SERVICE BULLETIN

APPLICABILITY: 2013MY BRZ **NUMBER:** 15-158-12
SUBJECT: Navigation/GPS Antenna Changes **DATE:** 10/24/12
 SD Card Exchange Program Information

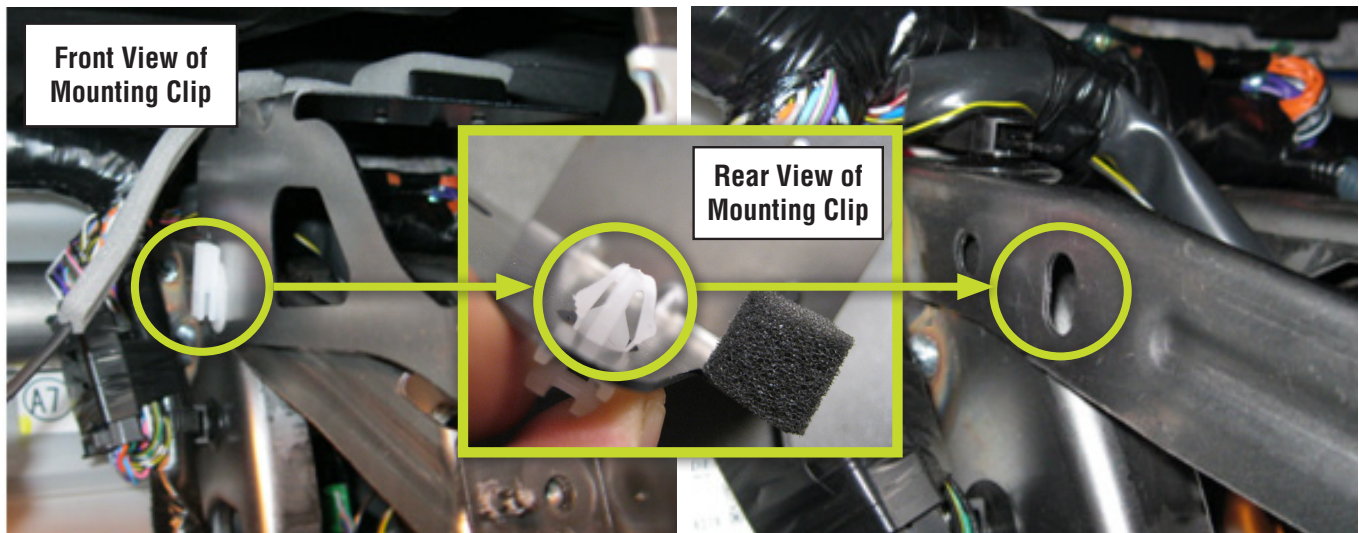
The photo below shows the revised GPS antenna / mounting bracket assembly along with an antenna lead extension harness already attached. **NOTE:** The revised GPS antenna / mounting bracket assembly you receive may have a longer 1-piece lead instead of a shorter lead with an extension pigtail as shown in the photo. Either configuration is acceptable to use for this procedure.

Install the revised GPS antenna / mounting bracket assembly. Confirm the white plastic mounting clip locks into the large oblong hole in the instrument panel support bracket properly before installing the mounting screw. **CAUTION:** Do not over-tighten the mounting screw.
